TOWN OF
BRECKENRIDGE

Planning Commission Meeting Agenda

Tuesday, April 7, 2020, 5:30 PM

Planning Commission Staff Report

Exterior Elevations
Scale: 1/4" = 1'-0"
Date: 02-12-2020

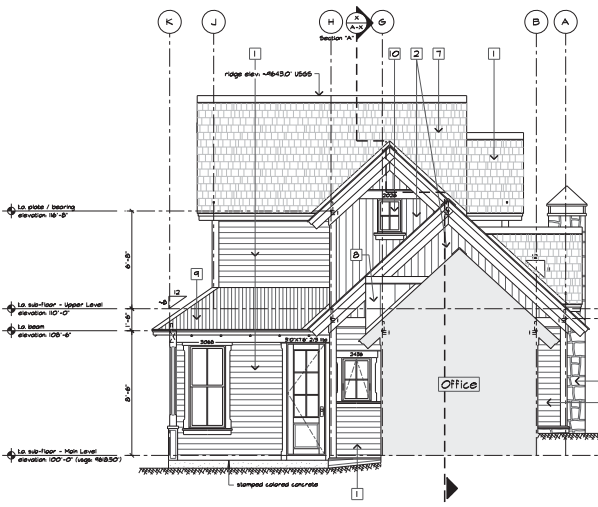
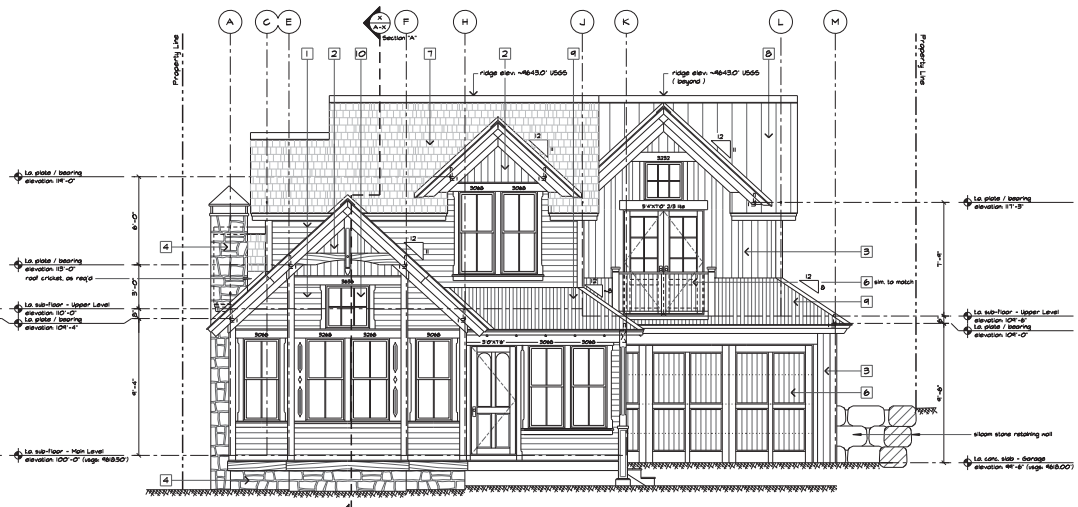
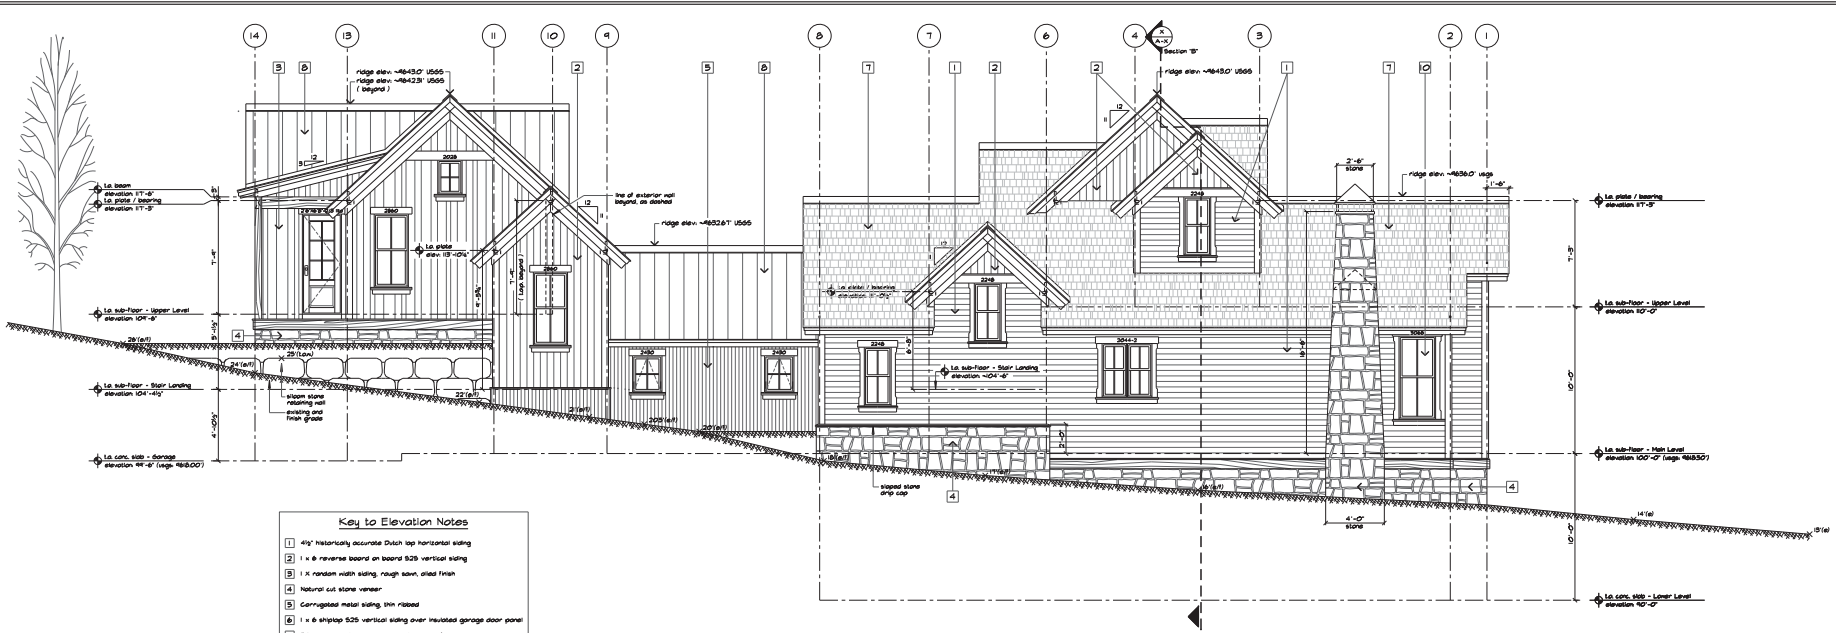
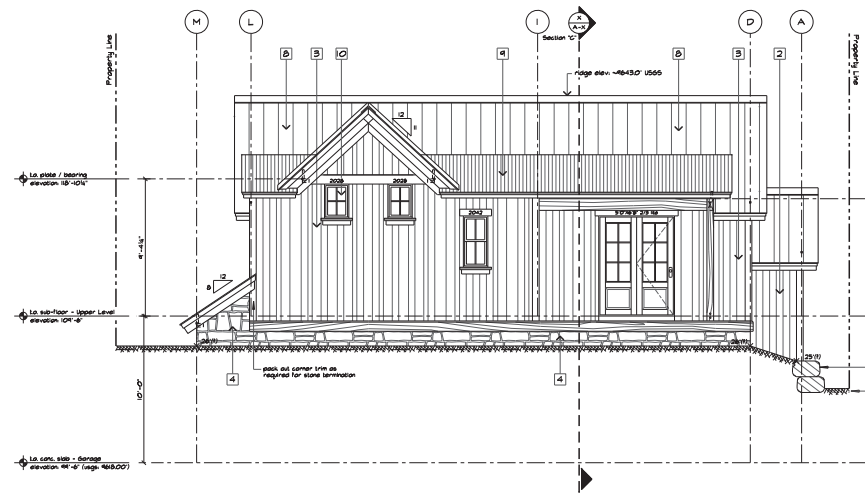
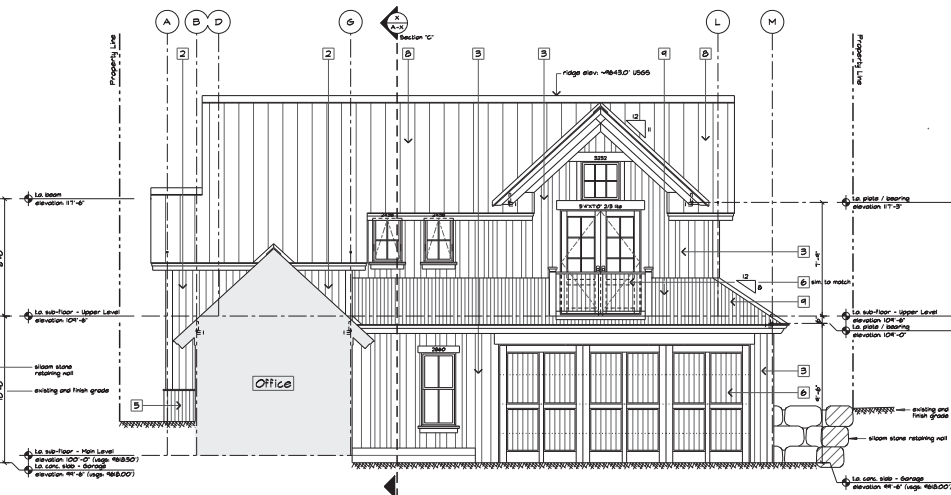
In response to the comments, the previously proposed French Doors were replaced with a single 2/3rds light door, flanked by double hung windows. Staff appreciates the changes to the project and believes the design now complies with Priority Design Standards 95 and 96 and Design Standard 91. Does the Commission concur?

Finally, staff appreciates the replacement of the connector's French doors with a single door as stipulated under Design Standard 80A. Staff believes the revised design follows the width, setback and simple design standards of Policy 80A. Does the Commission concur?

1. **Windows and Doors** - Staff believes with the elimination of the French Doors in favor of a single door on the connector the design now complies with Priority Design Standards 95 and 96 and Design Standard 91. Does the Commission agree?
2. **Connector** - Staff believes the revised connector design follows the width, setback and simple design standards of Policy 80A. Does the Commission concur?

| Heated concrete walkways: | 447 Sq. Ft. |

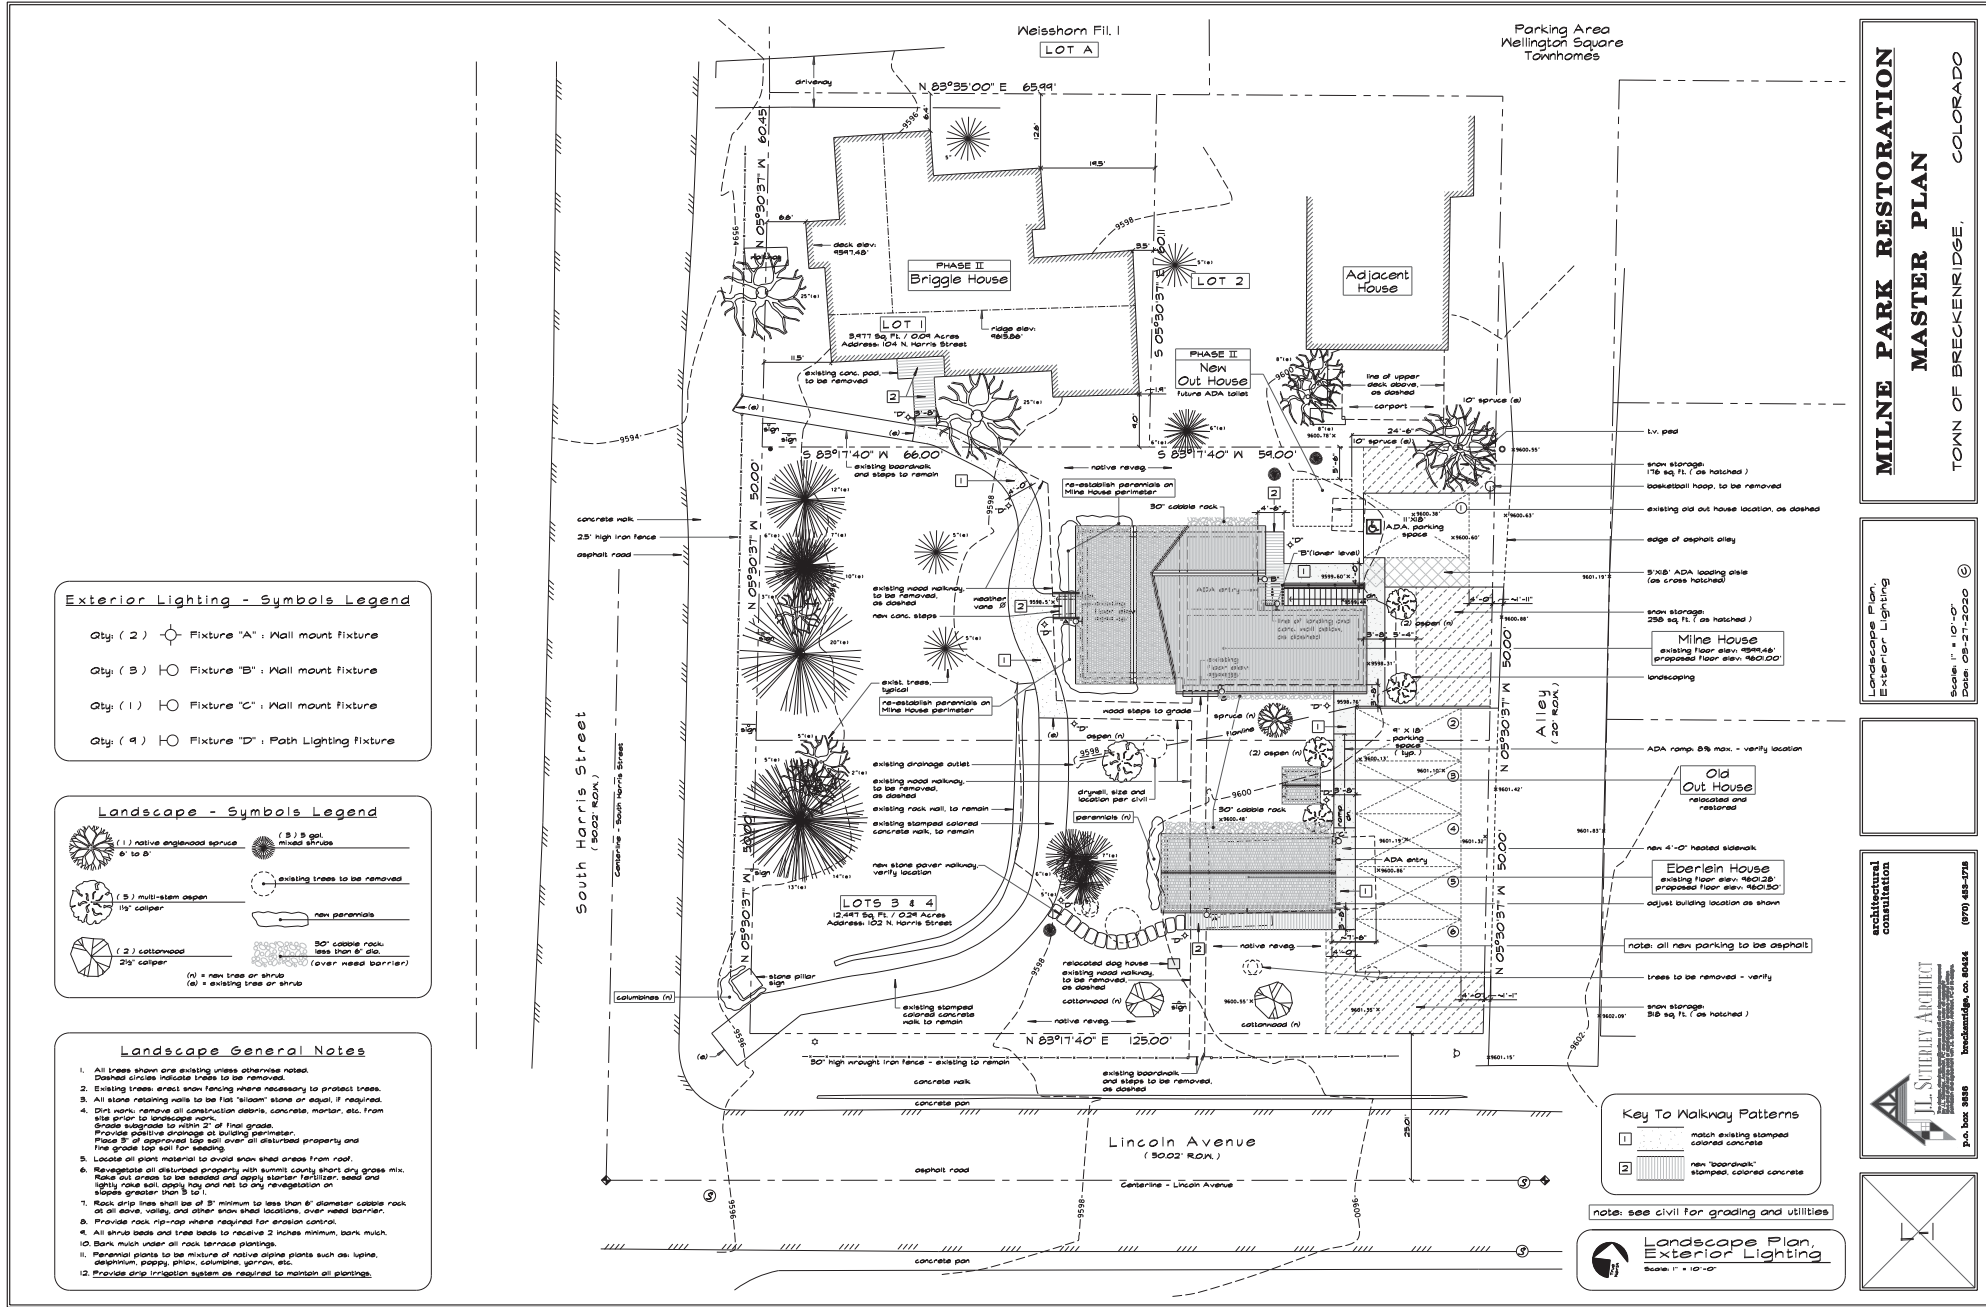
Mr. LaChance: We will either need to remove the heated sidewalk notation or change the point analysis, need to have the applicant weigh in on that.

- Mr. LaChance: We will need to hear from the applicant what they want to do in regards to the heated concrete note on the elevations. They could take up to -3 points of outdoor heated space, or remove the note on the elevations. I also want to be sure the Commission is aware that if we do apply Priority Design Standard 20 to the interior, it would be setting a precedent that would apply to future projects and private single family projects, for example. That precedent would not differentiate between Town Project or private use.

- Mr. LaChance: I have one final comment on the heated walkway note. Considering we've already opened and closed the public comment period, I would suggest we proceed with a condition that the note on the plans regarding heated sidewalk be removed prior to issuance of a Building Permit.

Mr. Schuman: I think the passing point analysis is incorrect because plans show a heated sidewalk and it fails Priority Design Standard 20, which is why I'm voting no.

Mr. Schroder made a motion to recommend the Town Council approve the project along with a condition to remove the heated outdoor space note. Mr. Schuman seconded the motion. The motion received 3 votes for and 2 against (Mr. Giller, Mr. Schuman and Mr. Moore no, Mr. Schroeder and Mr. Gerard yes, Ms. Leidal-no vote). Mr. Schroder withdrew his motion for the purpose of additional discussion, prior to the final Commissioner's vote.

MILNE PARK RESTORATION
EBERLEIN HOUSE
TOWN OF BRECKENRIDGE, COLORADO

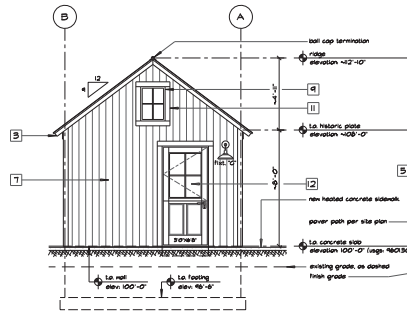
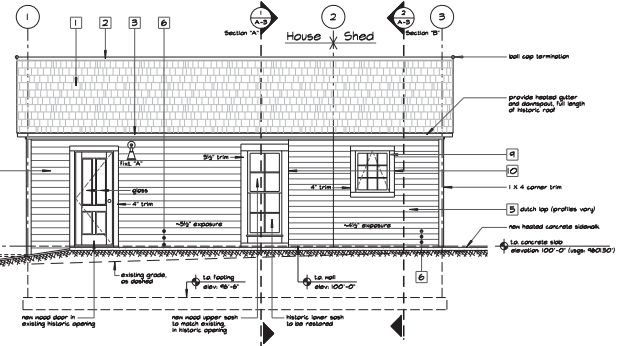
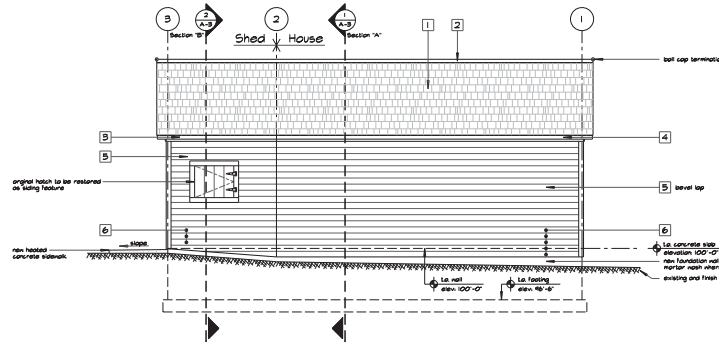
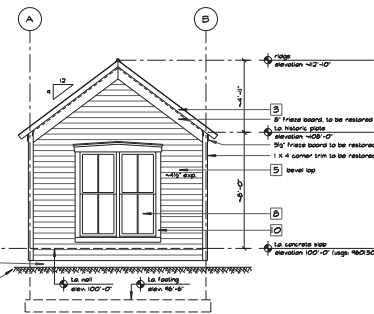
Mr. Giller: I wanted to go through the drawings. Is the front door of the Eberline being lost? (Mr. LaChance: It is being replaced.) It is a loss of historic fabric. Are we losing 3 of the 5 historic windows? (Mr. LaChance: Yes, windows are proposed to be replaced, but the window openings are proposed to remain the same.) Windows and doors are character defining features. In regards to the interior, are we losing the floor? (Mr. LaChance: The plans specify it is being replaced with concrete.) Is the interior ceiling being lost? (Mr. LaChance: Yes, regarding interior work, I will defer to the architect to answer questions regarding interior work. As I mentioned in the staff report, staff does not review interior modifications.) Are we losing the interior wall and wall paper? (Mr. LaChance: To be consistent, I will defer to the architect to answer that because it is interior and our code does not apply.) Are we losing the interior millwork? (Mr. LaChance: Again, I will defer to architect because it is interior.) I support the BHA's interpretation of the home, but I find it odd we are losing so much to interpret it.
